**Environmental
Protection Agency**

August 9, 2011

RE: ASHTABULA COUNTY
JEFFERSON TOWNSHIP
DOLLAR GENERAL
NPDES PERMIT NO. OHC000003
OHIO EPA PERMIT NO. 3GC05416*AG
CONSTRUCTION STORM WATER

Figure 3. Please block the orifice and implement appropriate inlet protection until the site is stable.

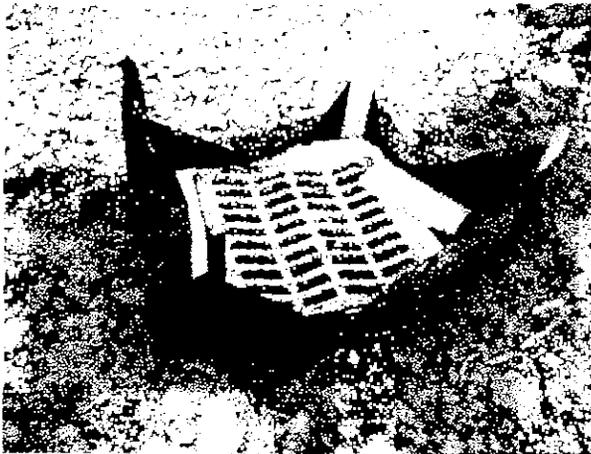
- **The inlet protection for the catch basin in the swale on the back side of the building is inadequate.**
 - Please stabilize the swale so that inlet protection can be removed from the catch basin. Until then, please block the orifice on the catch basin completely and reinstall adequate inlet protection for the catch basin (See Figure 3).
